PCN
Change of tape and reel for CeraLink LP capacitors

Enclosure PCN (ID No. PPD3/T122)

1. ID No.: PPD3/T122		**2. Date of announcement:** September 15, 2017	
3. Product / product group: CeraLink capacitors LP Series	**Old ordering code:** B58031U* and B58031I*	**New ordering code:** No change	**Customer part number:** NA

Previous tape of CeraLink LP capacitors with J-style leads, for example:

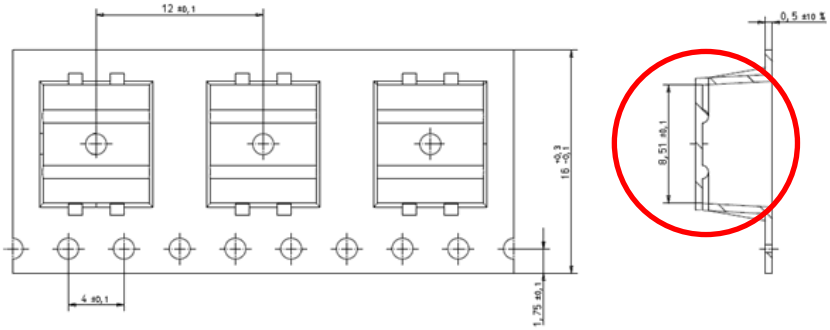
The tape and reel for the B58031U* and B58031I* series of CeraLink® LP capacitors will be modified in order to improve the mechanical stability. The change of tape only affects the bottom of the cavities, where a 3D profile will be added for improved stiffness. The new reel will made of a single piece and have a different color (grey). The dimensions of the new reel are unchanged. The changes do not affect the function or processibility of the components.

The tape and reel for the B58031U* and B58031I* series of CeraLink LP capacitors will be modified in order to improve the mechanical stability. The change of tape only affects the bottom of the cavities, where a 3D profile will be added for improved stiffness. The new reel will made of a single piece and have a different color (grey). The dimensions of the new reel are unchanged.
